UNITED STATES PATENT AND TRADEMARK OFFICE

APPLICATION NO.	FILING DATE	FIRST NAMED INVENTOR	ATTORNEY DOCKET NO.	CONFIRMATION NO.
10/691,854	10/23/2003	Mark H. Falahee	FLH-10702/29	6727
25006	7590	03/23/2006	EXAMINER	
GIFFORD, KRASS, GROH, SPRINKLE & CITKOWSKI, P.C			PREBILIC, PAUL B	
PO BOX 7021			ART UNIT	
TROY, MI 48007-7021			PAPER NUMBER	
			3738

Office Action Summary	Application No.		Applicant(s)	
	10/691,854		FALAHEE, MARK H.	
	Examiner		Art Unit	
	Paul B. Prebilic		3738

Fig - 7A

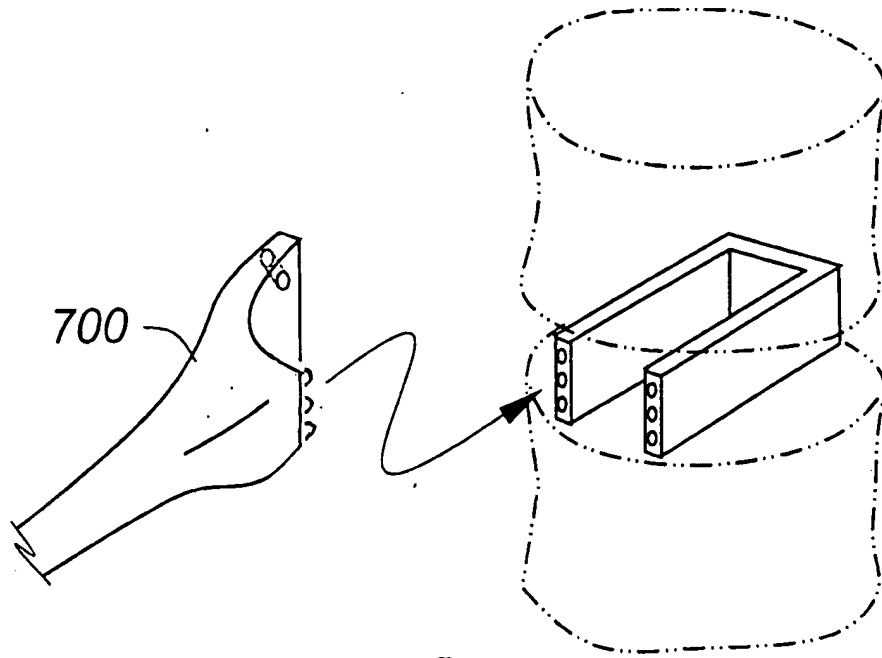
Proposed drawing changes were received on January 26, 2006. The proposed changes were not approved because Figures 7A and 7B attempt to add new matter to the specification. In particular, the detailed features of shape and details of the figures do not appear to have original support from the specification or original drawings. The drawing changes proposed for Figures 9A to 10B are not acceptable because they do not have projection lines indicating that they are expanded views. Furthermore, the drawings are of poor quality and do not comply with the requirements of Rule 84.

Changes
Not
Approved
FBP
3/20/06

New corrected drawings in compliance with 37 CFR 1.121(d) are required in this application because the ones filed June 13, 2005 are not acceptable. Applicant is advised to employ the services of a competent patent draftsman outside the Office, as the U.S. Patent and Trademark Office no longer prepares new drawings. The corrected drawings are required in reply to the Office action to avoid abandonment of the application. The requirement for corrected drawings will not be held in abeyance.

Fig - 10A

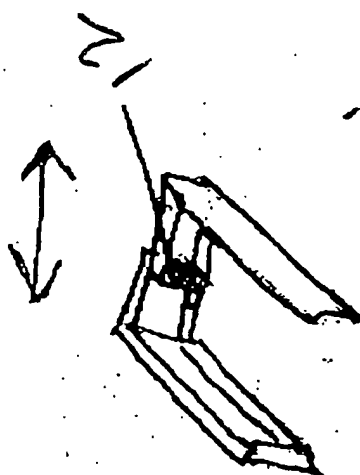
Changes
Not
Approved
3/20/06
